Cardinia Shire Council

# **Key Changes to Officer's Urban Design Framework – Key Directions & Sections**

Appendix B

### Section 1 Exhibited:

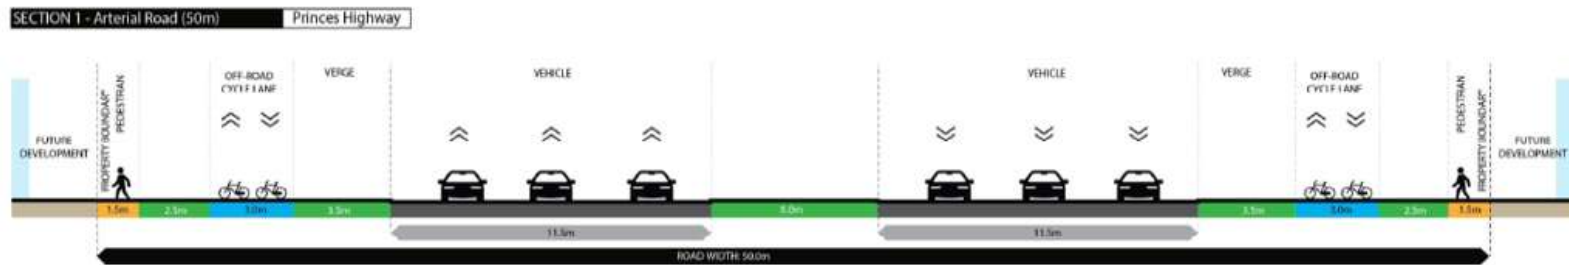
Trees removed due to comments from traffic and engineering concerning the proximity of trees along arterial roads. The Department of Transport and Planning (DTP) is the responsible authority for arterial roads.

Officers will encourage the appropriate greening of these spaces however its approval is the responsibility of DTP.

## Section 2 Exhibited:

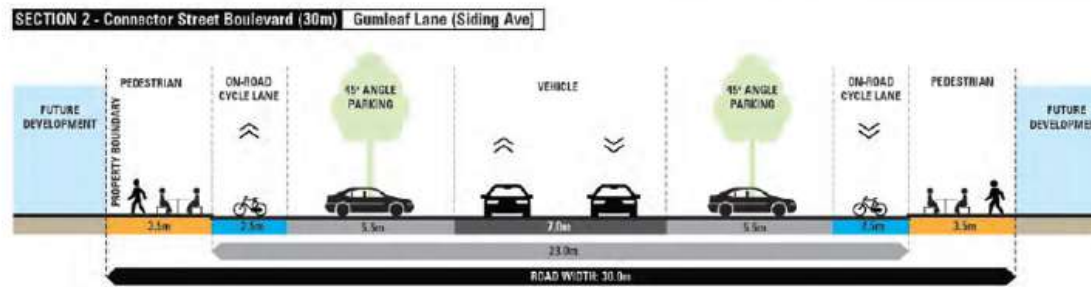
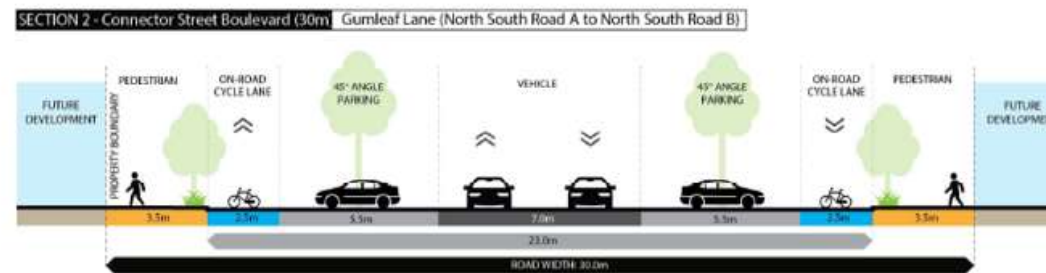
VPA requested additional trees to assist in achieving a 30% tree canopy coverage within streetscapes. This change is prompted by new guidelines from VPA, introducing increased standards for greening and cooling communities.

### Section 4 Exhibited:

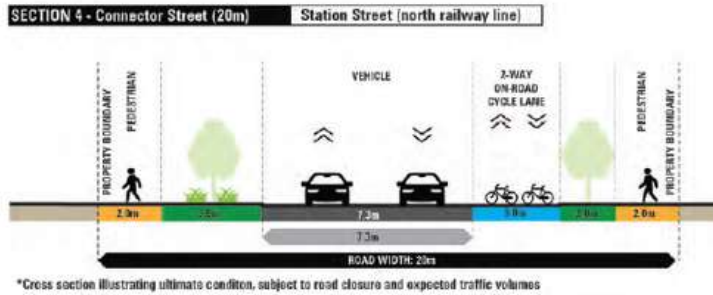
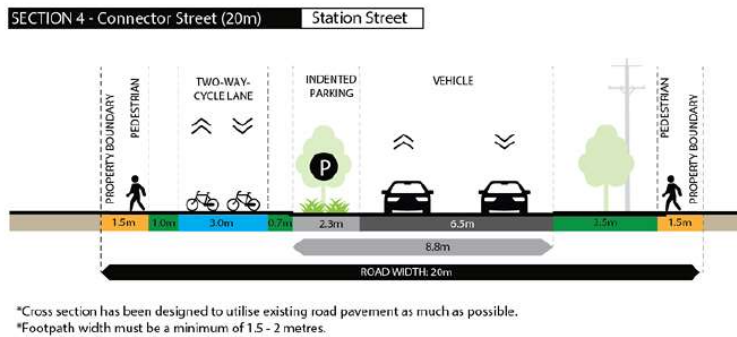
The electricity lines and open drain along the western side of Station St compromise the area available for a pedestrian path and protected cycle lanes.

Traffic requested indented parking be provided given the street is adjacent to commercial properties.

VPA requested that path widths be shown as a range to ensure a wider pedestrian area where the road section permits.

## Section 5 Exhibited:

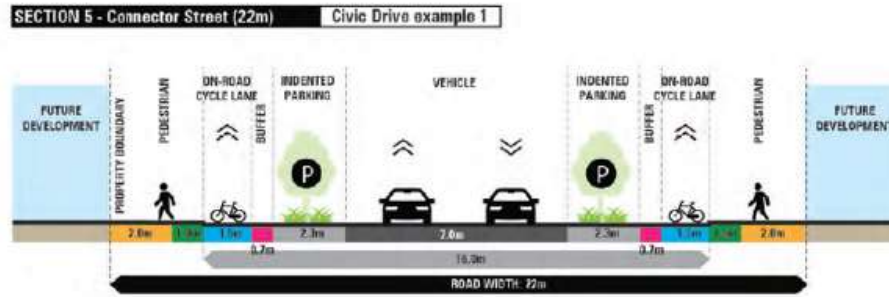
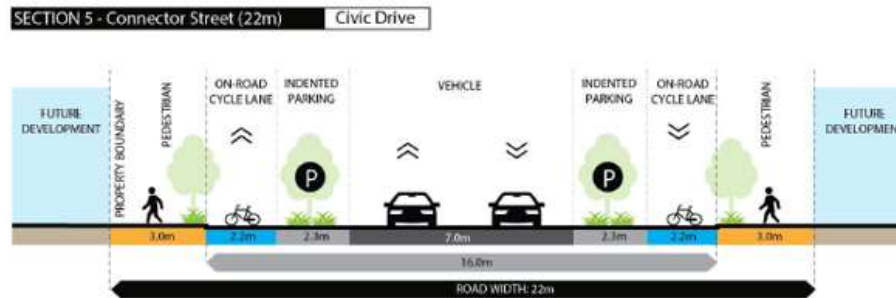
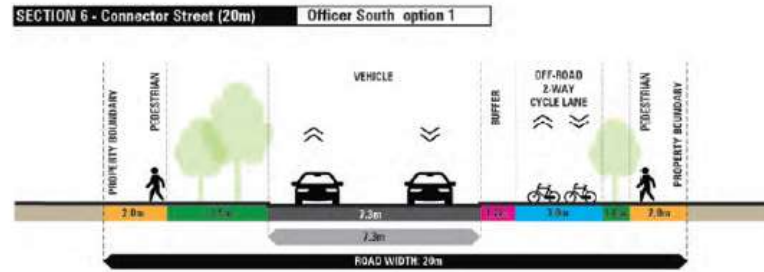
VPA requested additional trees to assist in achieving a 30% tree canopy coverage within streetscapes.

Buffer distances incorporated into cycle lane widths.

Pedestrian path shown at a minimum width of 3m allowing for outdoor dining opportunities as well as landscaping.

### Section 6 Exhibited:

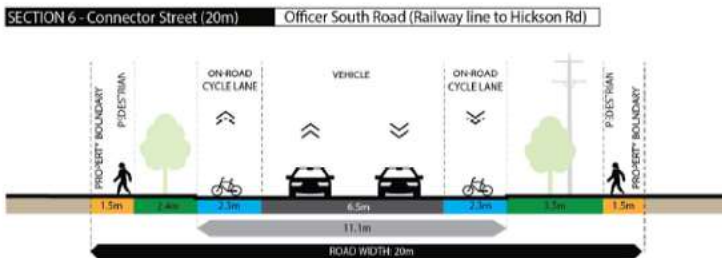
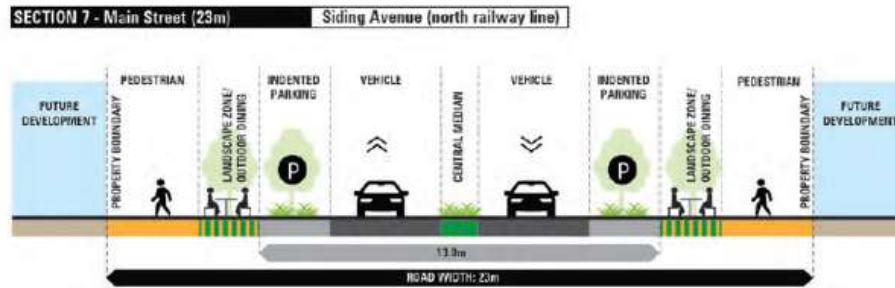
The electricity lines and open drain along the western side of Station St compromise the area available for a pedestrian path and protected cycle lanes.

Buffer distances incorporated into cycle lane widths.

VPA requested that path widths be shown as a range to ensure a wider pedestrian area where the road section permits.

\*Cross section has been designed to utilise existing road pavement as much as possible.  
 \*Footpath width must be between 1.5-2m

## Section 7 Exhibited:

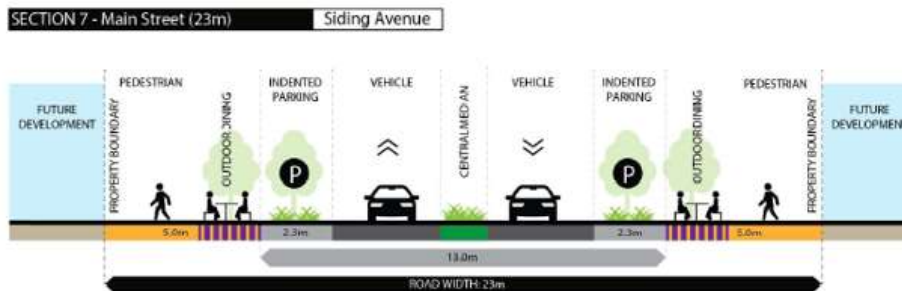
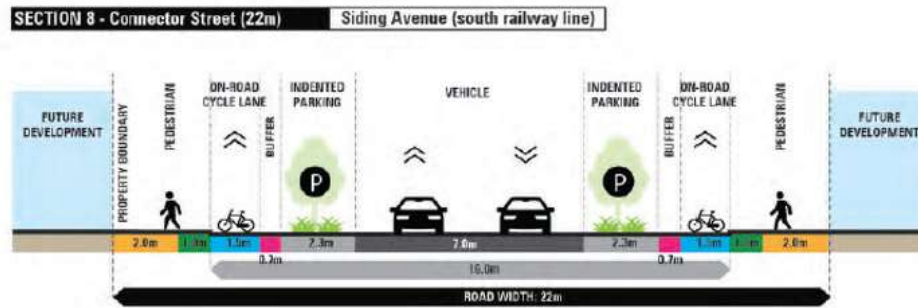
Terminology updated to assist with the distinction between an outdoor dining area and a landscaped area.

Note: VPA inflexible on the central median being altered.

### Section 8 Exhibited:

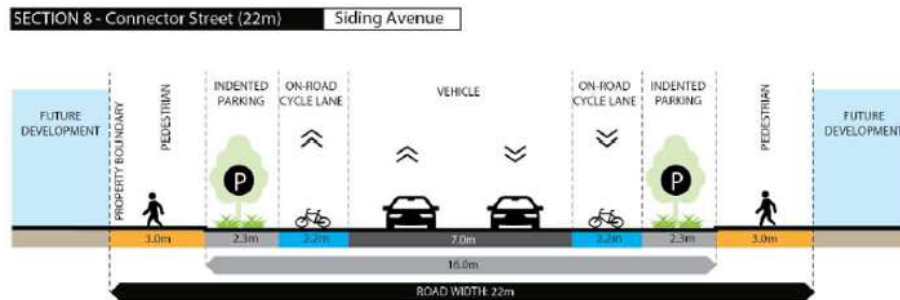
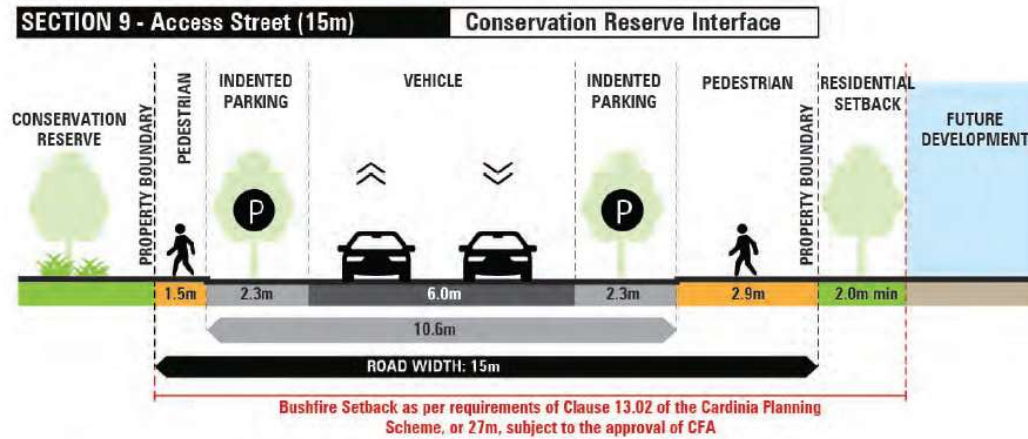
Whilst the exhibited section is the desired outcome by Council's urban design team offering greater protection to active transport users, there are sections of Siding that have already been built e.g., south of the railway line. Council's engineering team has requested that the section be consistent with as constructed conditions.
